Greater Geelong Planning Scheme Amendment C433ggee Pakington Street and Gordon Avenue Urban Design Frameworks

Panel Report

13 April 2026

Figure 2. Future Park Indicative Open Space Interface

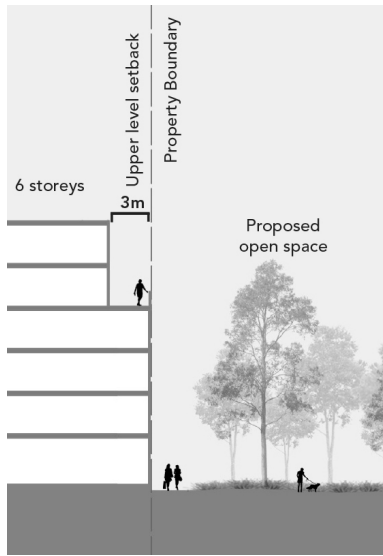
[Editing Note: ground floor building setback 2m from proposed open space.]

[Editing Note: replace 'Proposed open space' with 'Indicative open space']

- a transition zone of about 2 metres between public parkland and private development, as reflected in DDO56 Version 1, as this will provide a better interface at the lower levels
- clarifying that balconies should not encroach into the side setbacks because there are outdoor living spaces that should not form part of the built form break.

Figure 6. Preferred side separation for buildings up to 8 storeys built to boundary

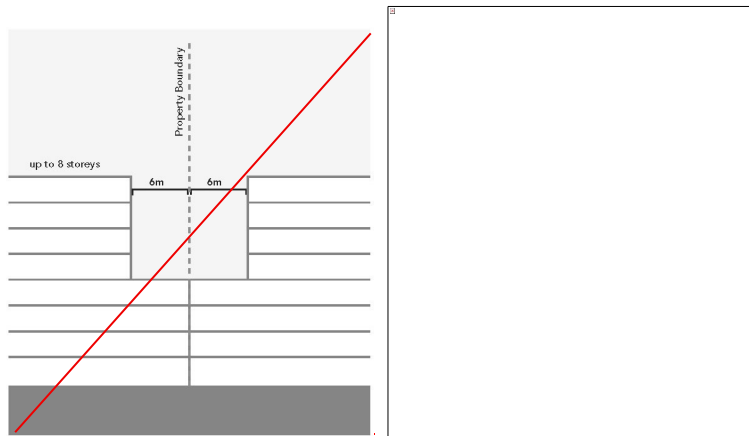
[Editing note: Figure on left replaced by Figure on right which shows two additional floors]

Figure 7. Preferred side separation for buildings over 8 storeys built to boundary

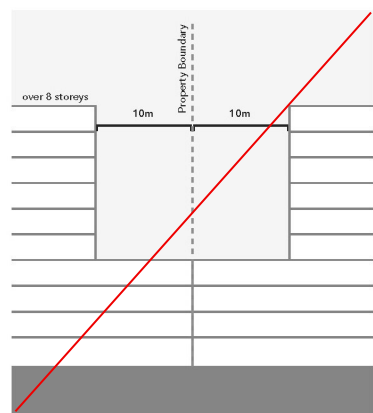
[Editing note: Deleted]

- a) reduce the discretionary tower side separation distance from the property boundary from 9 metres to 6 metres for built form above 8 storeys**
- b) clarify that balconies should not encroach into setbacks.**

Figure 4. Type 6D residential interface

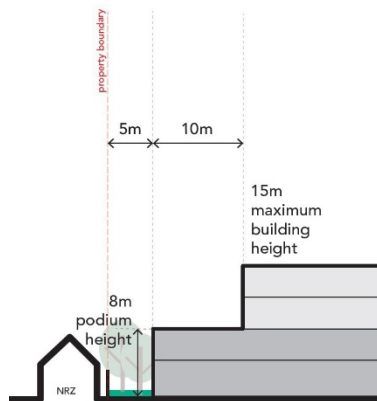
[Editing Note: Deleted]

- a) delete Figure 4: Type 6D residential interface**
- b) remove Type 6D Rear Interface from the image and legend from Map 2**
- c) realign the precinct boundary to remove 28-64 Pakington Street (Rail sidings site) from Maps 1, 2 and 3.**

Figure 78. Public Open space interface

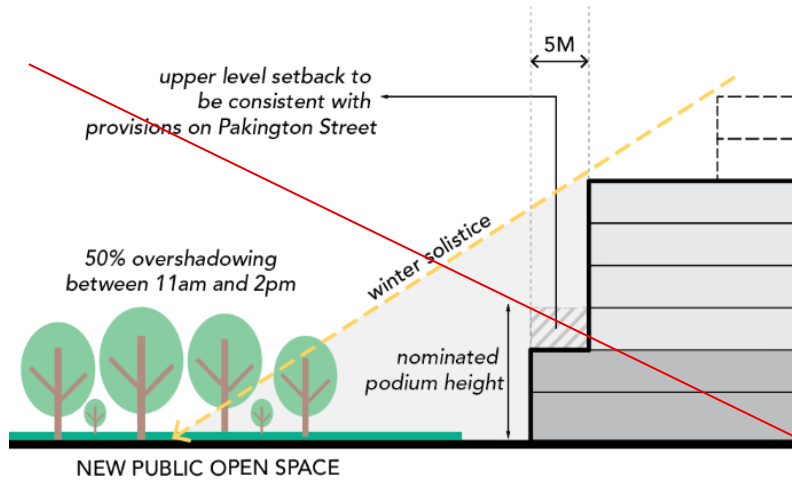
[Editing Note: Deleted]

[Editing Note: Diagram to updated to reflect the scale of the Former Donaghy's Rope Walk building and the indicative building massing further to the north]:

With the removal of the rail sidings yard site (as discussed in Chapter 7.3) and the indicative open space at the south-east corner of the Pakington Strand site, only one indicative open space remains. Accordingly, DDO57 Figure 8 should be revised to better reflect the scale of the Former Donaghy's Rope Walk building and the discretionary maximum building heights to the north.

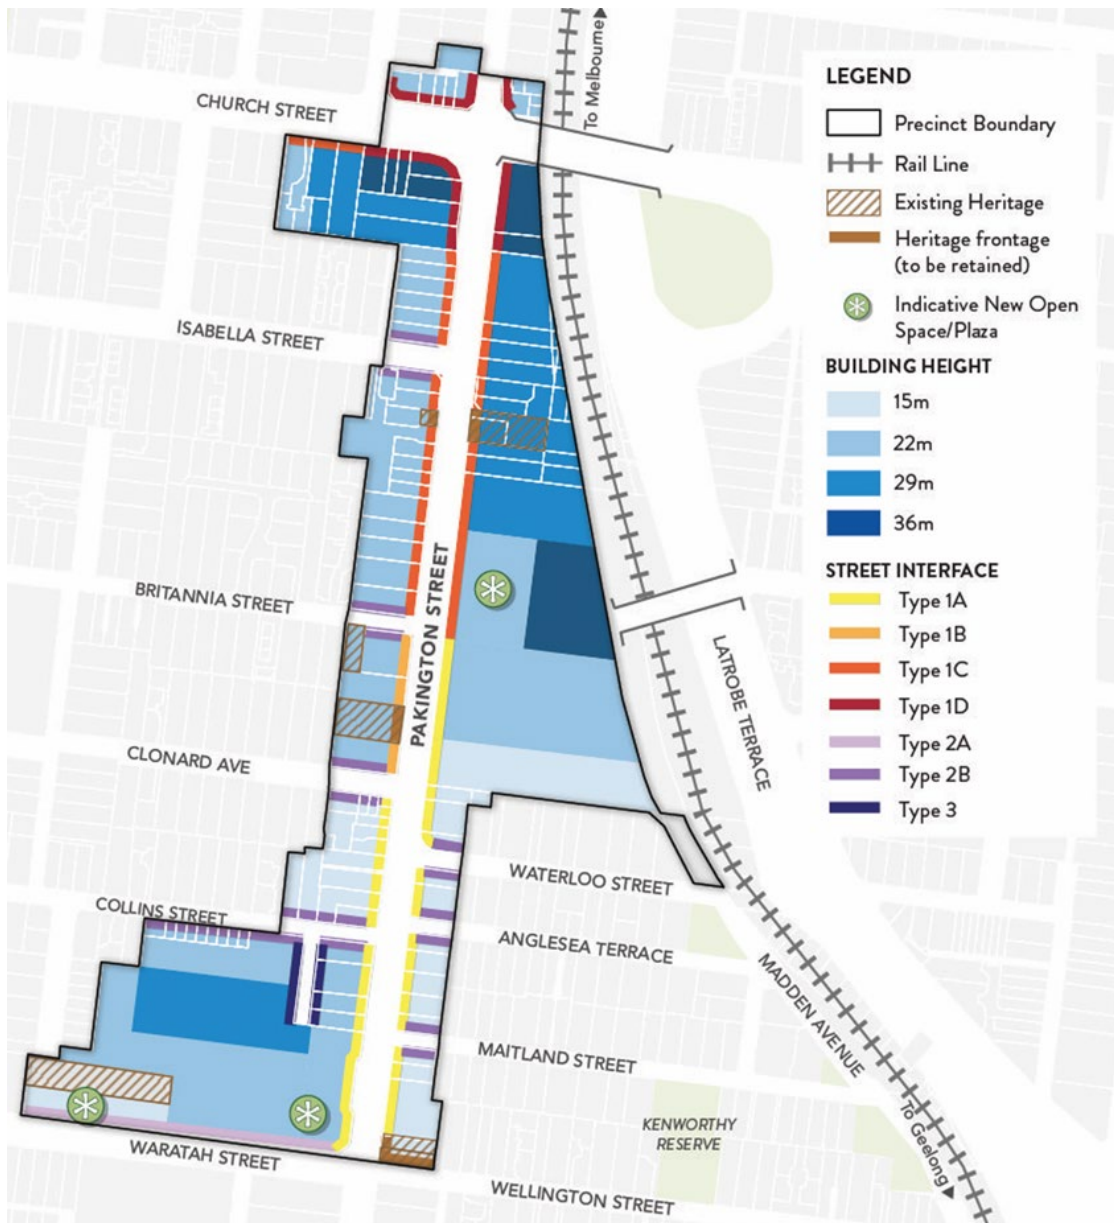
[Editing Note: Realign the Precinct Boundary to remove 28-64 Pakington Street (Rail sidings site) from the Precinct]

[Editing Note: identify the Pakington Strand Strategic Site]

[Editing Note: Amend the Legend to read 'Indicative New Public Open Space']

[Editing Note: Remove indicative open space icon from SE corner of Pakington Strand Strategic Site]

Map 3 to Schedule 57 to Clause 43.02

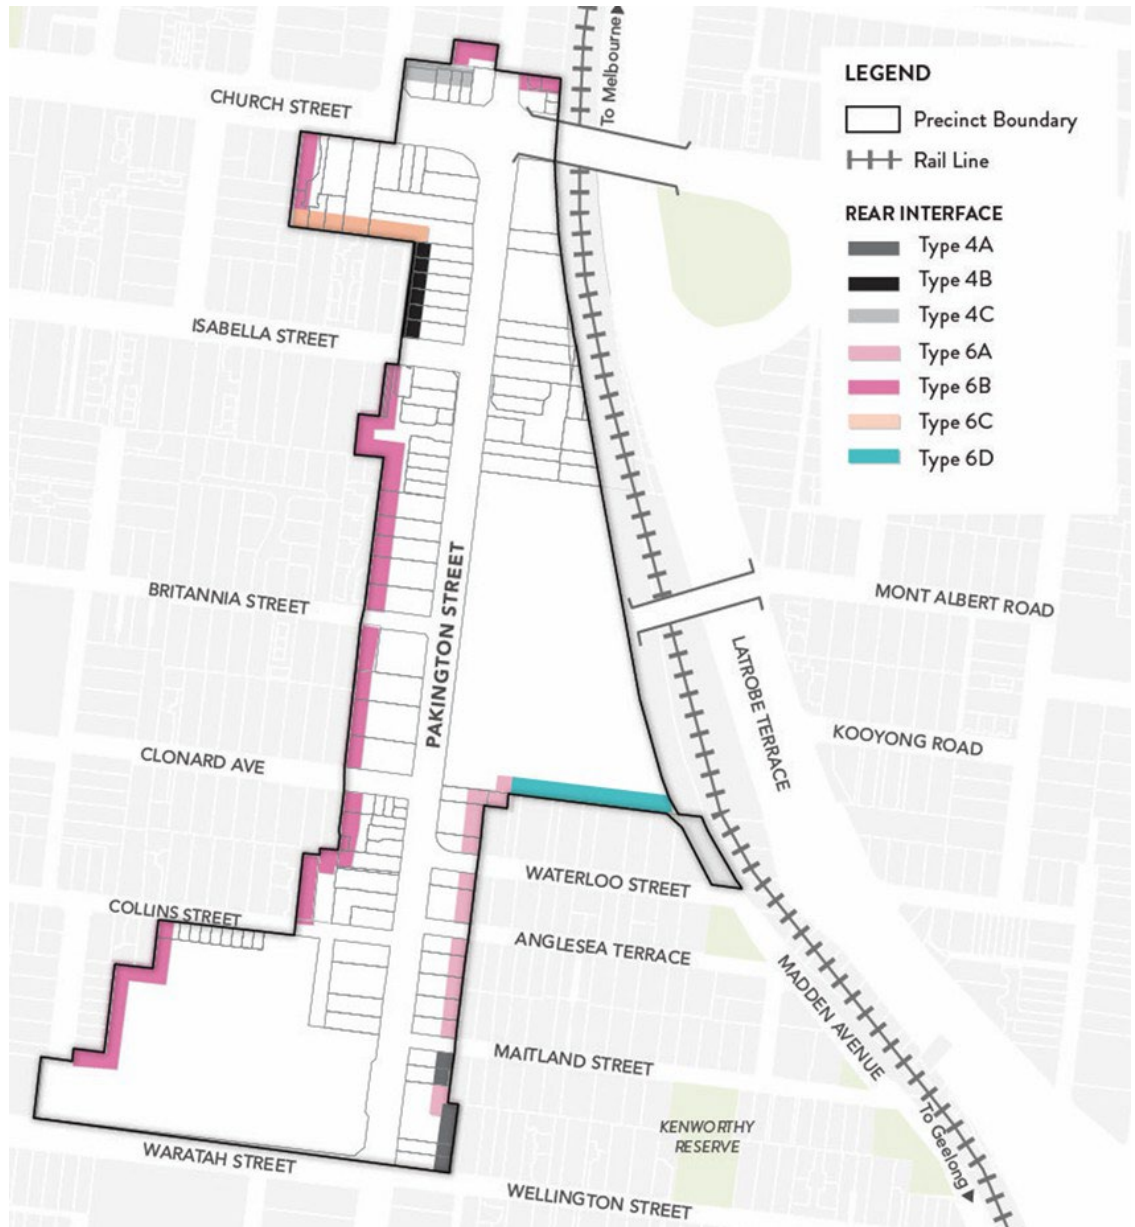
[\[Editing Note: Realign the Precinct Boundary to remove 28-64 Pakington Street \(Rail sidings site\) from the Precinct\]](#)

[\[Editing Note: Delete Type 6D from the Map and Legend\]](#)

[\[Editing Note: In the Legend, delete 'Rear interface'. Add a heading 'Laneway Interface' to apply to Type 4A, 4B and 4C and 'Residential interface' to apply to Type 6A, 6B and 6C.\]](#)
